Re NWRIC Submission into Reform Option for ACCU Scheme Landfill Gas Methods

The National Waste and Recycling Industry Council (Council) makes its submission in response to the Department's Options Paper on reform options to the ACCU Scheme Landfill Gas Methods (*Reform Options Paper*).

NWRIC CONFIDENTIAL OPTIONS PROPOSAL
ACCOUNTING FOR METHANE ABATEMENT
USE BETWEEN TWG INDUSTRY PARTICIPANTS AND THE DEPARTMENT
OCTOBER 2023

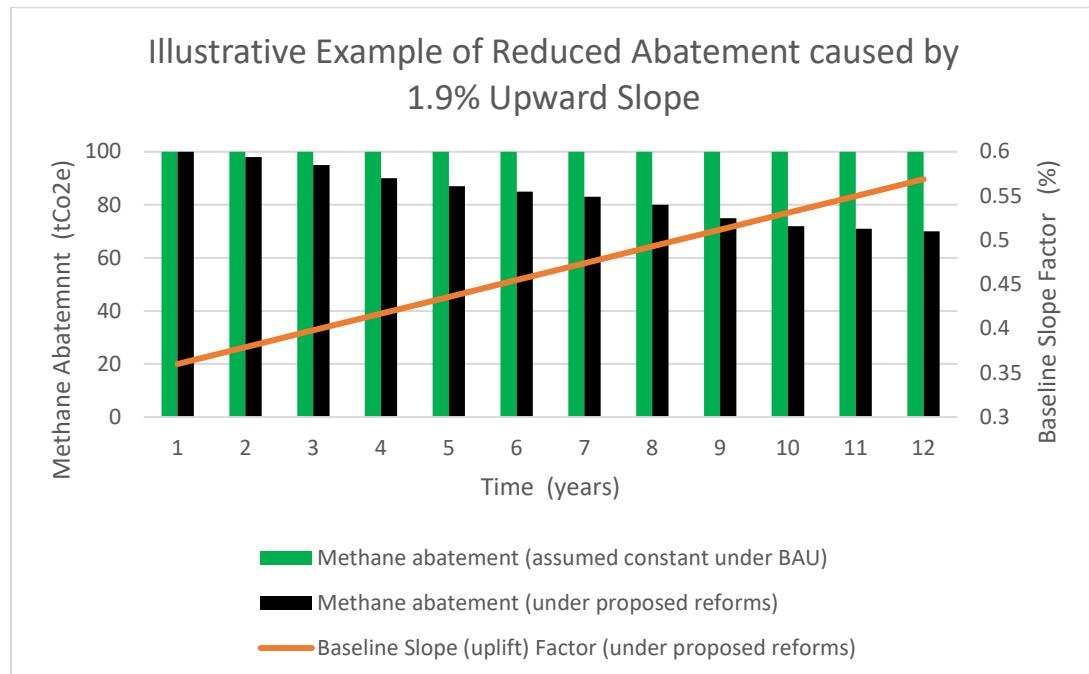
A baseline gradient slope of between 0.5% and 0.92% is vitally important to ensuring investment in methane abatement continues and that methane emissions do not increase with the expected increase in waste generation. In respect to “Increasing Baselines over time” Council members are fundamentally challenged with introducing the upward sloping gradient and our forensic analysis of the proposal which has no international standing or comparisons show that higher rates of baseline increase (1.9% or even 1.5%) would:

- Significantly reduce the viability of investments – with some existing sites needing to cease methane capture within 5 years and new investments in capturing methane reducing or ceasing altogether
- Rapidly reduce ACCU supply (estimated at millions units over forward)
- Reduce landfill gas capture and increase methane emissions.
- Reduce opportunities for landfill gas to help establish biomethane or sustainable aviation fuel industries which are critical for decarbonisation of the gas network and hard-to-abate sectors, and
- increase cost of living pressures as Council rates and waste fees are increased to cover costs of landfill gas capture.
- Provide no incentives for the 100's of small landfills or new facilities to be developed

Adopting this measurement will further discourage all new investment in landfill gas abatement projects and therefore the generation of further ACCU's. There is no step change improvement in landfill operational practices or innovation in landfill gas capture that could possibly keep pace with the proposed 1.9% or 1.5% upward slope.

Capture efficiency rates including flaring activities (2021)

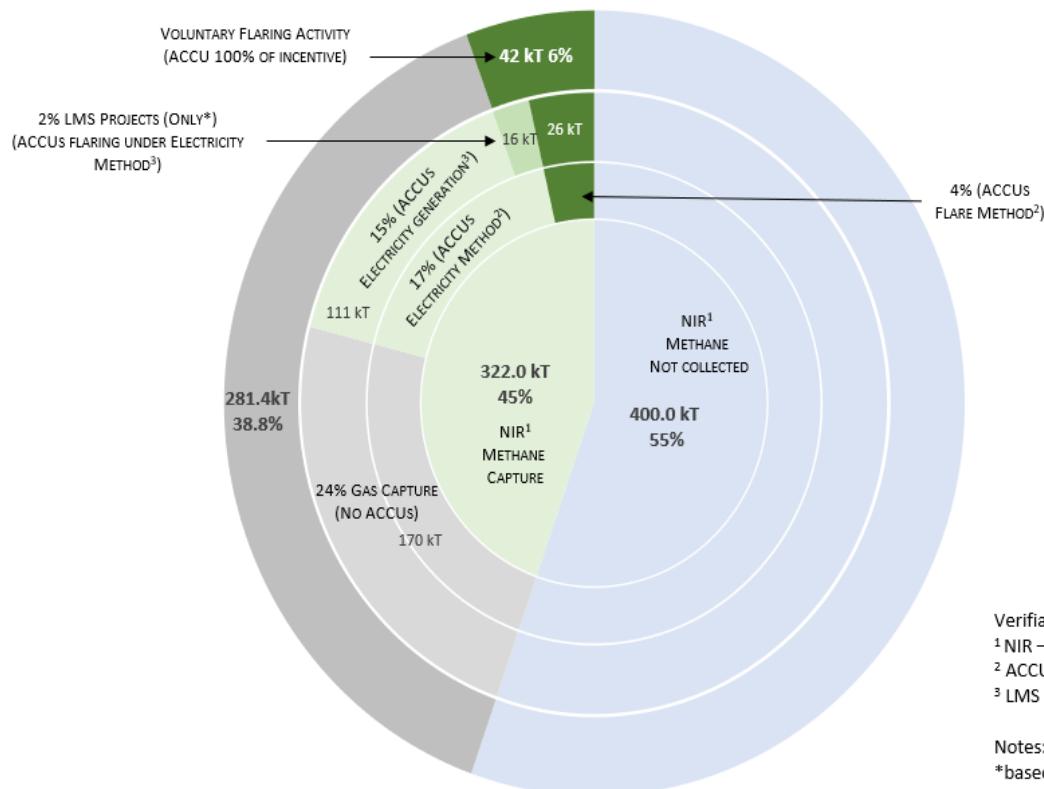
The diagram depicted shows that:

- The impact when methane capture attributable to all ACCU incentivised flaring only projects is removed from total landfill methane capture (using National Inventory and ERF Registry data).
- Substantial flaring is also voluntarily occurring at electricity generation projects where ACCUs have directly incentivised methane destruction. When the methane destruction from just one NWRIC member's flaring (LMS) from these projects is also subtracted from the National Inventory data, the capture efficiency reduces to under 39%. If this is extrapolated to include all electricity projects in the sector, capture efficiencies would further reduce to around 37%. Actual unincentivised activity (BAU) will therefore be less than that again.

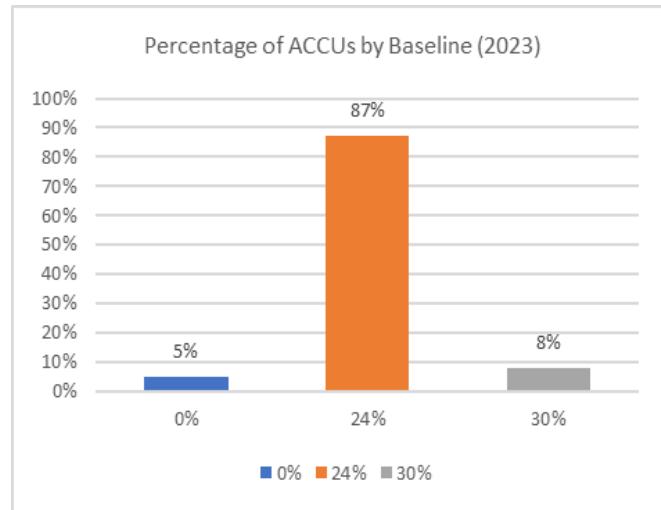
Consideration of these international rates shows that a capture efficiency in the low-mid 30s would be comparable to those being achieved internationally with various incentive schemes in place, noting that the average capture rate is 34% and there are large variations in rates reported between individual countries. Flaring reporting is often separately available and reveals that an average capture rate attributable to energy recovery would be less than 29%.

Notably, these findings also confirm that Canada, the most comparable nation to Australia in respect of economic character and geographic considerations, has a total capture efficiency rate of 35% and when flaring is removed this reduces to only 16%.

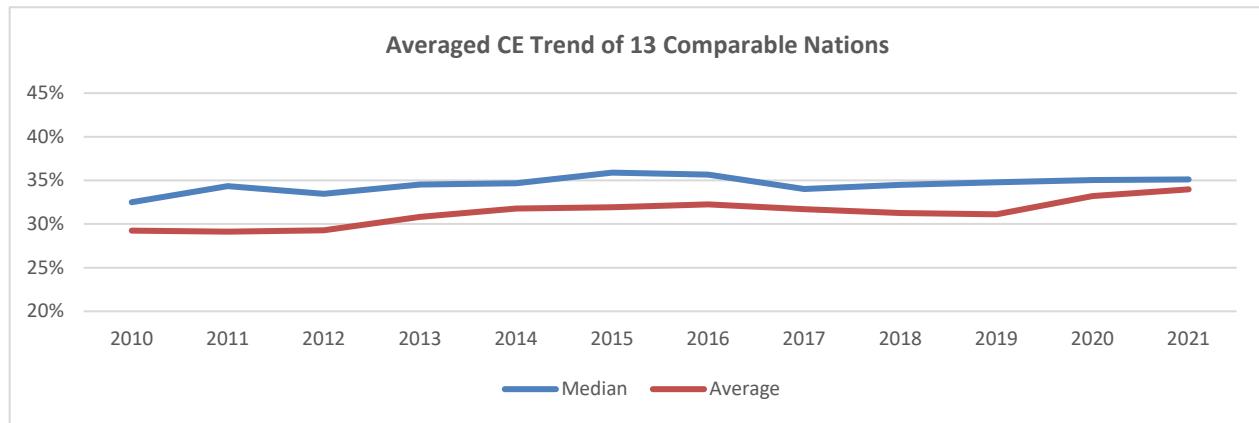
The chart depicts the international average capture efficiency over time. Using the 13 countries already reported in this paper over time reveals a comparable pattern of relatively stable capture efficiencies over the past decade.

Domestic and international patterns highlight:

- The introduction of incentives have driven significant increases.
- Smaller increases in capture efficiencies are subsequently the norm.

The NWRIC upward sloping baseline proposal for consideration

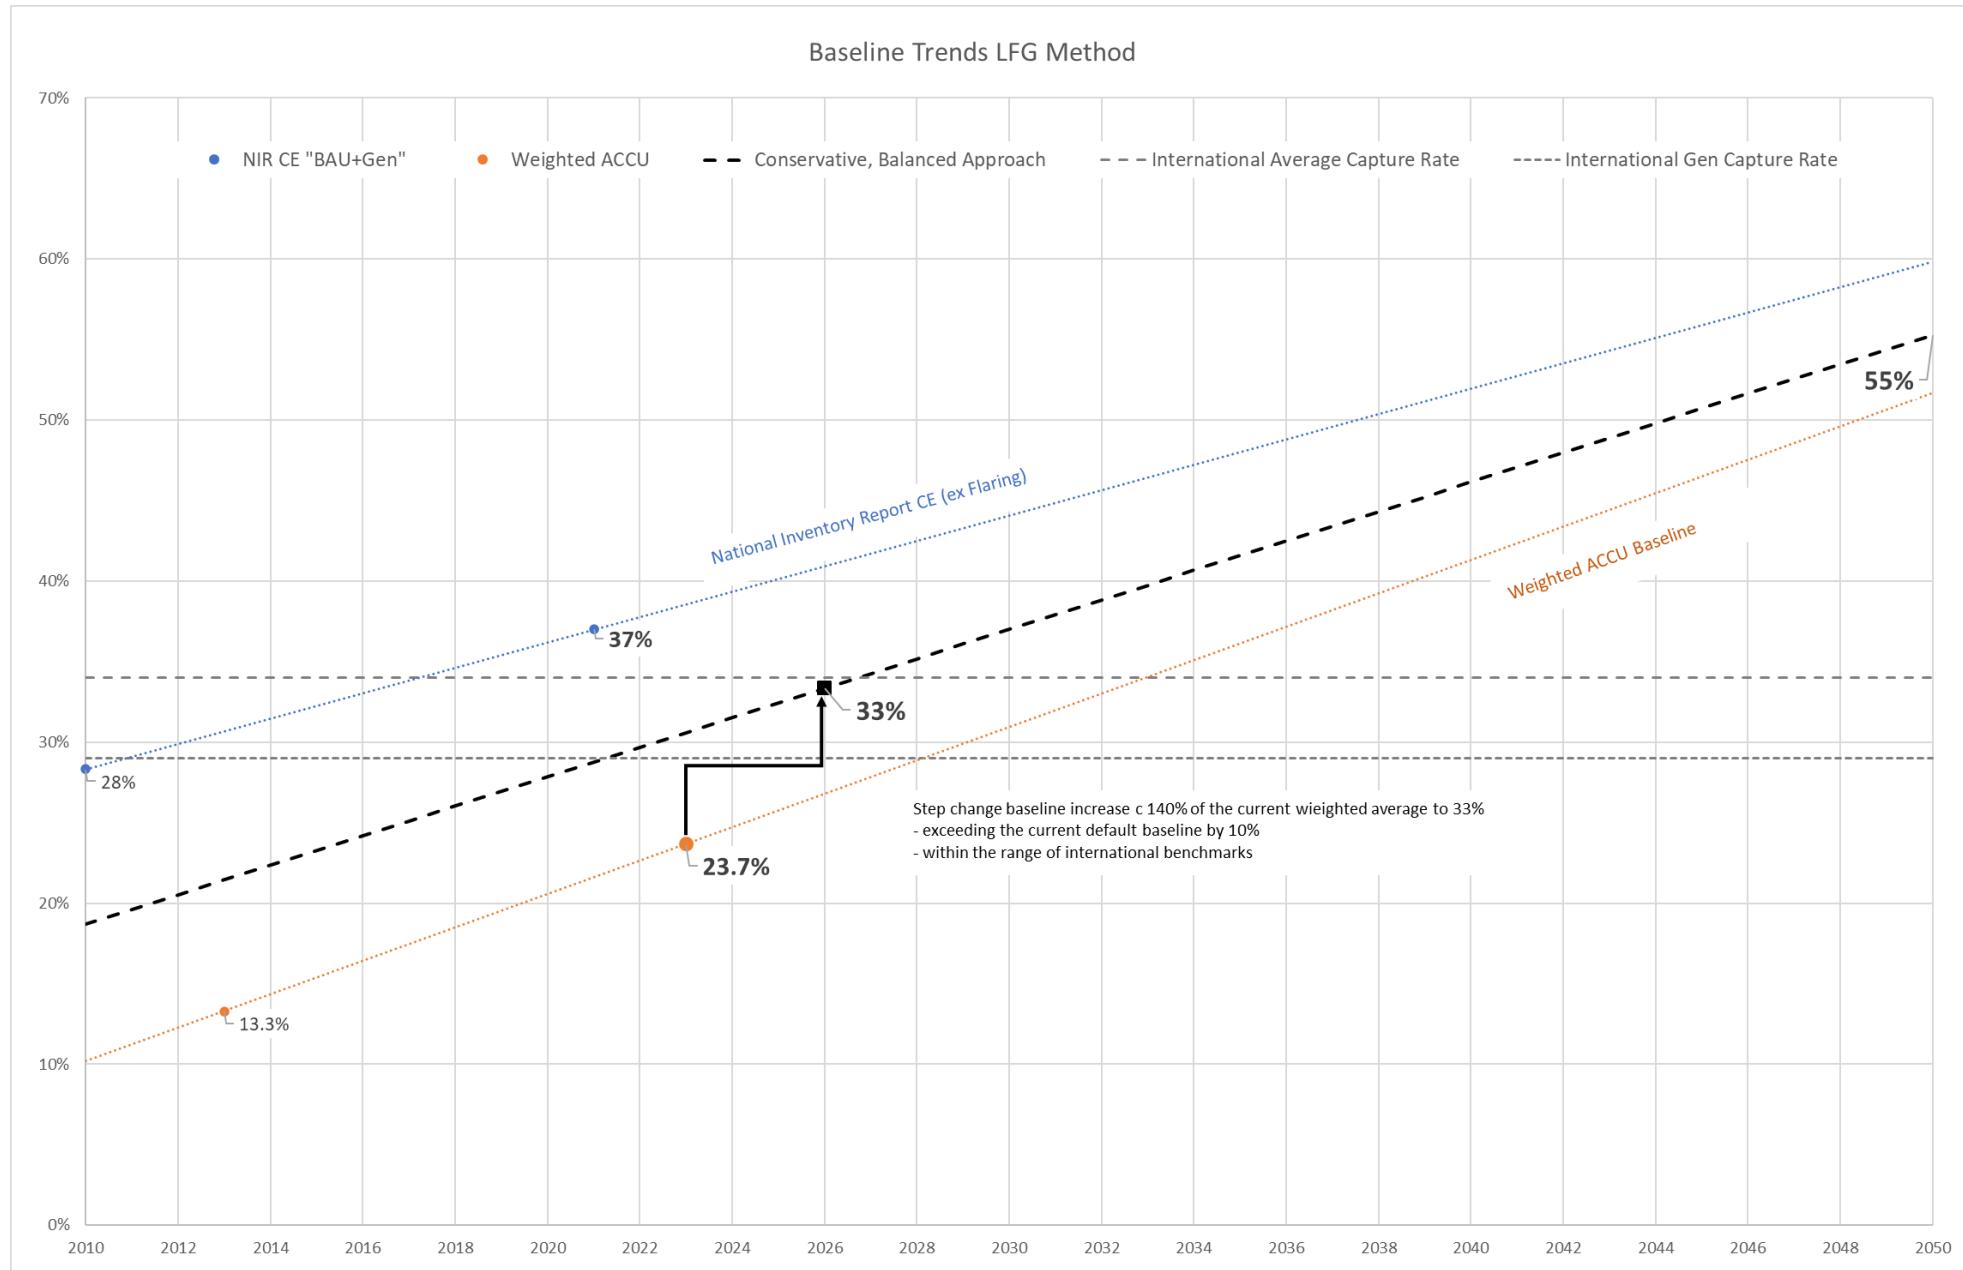
The Council proposes a model, (depicted over the page), that considers overarching National Inventory Data across time relative to weighted averages across time and international capture comparisons for a balanced position, with:

- The higher upward sloping line uses BAU with ACCUs (minus flaring) as a reference point for a projected trajectory.
- The lowest upward sloping line uses actual weighted baseline rates to reflect what the sector has worked to and may achieve on a consistent trajectory.
- The middle upward sloping line depicts the proposal as a fair balance between these and having regard to international average and median capture efficiency rates (depicted in the horizontal lines).

This proposal would see the baseline rise from 33% in 2026 – that is, it begins with the step change described above – rising to 55% by 2050.
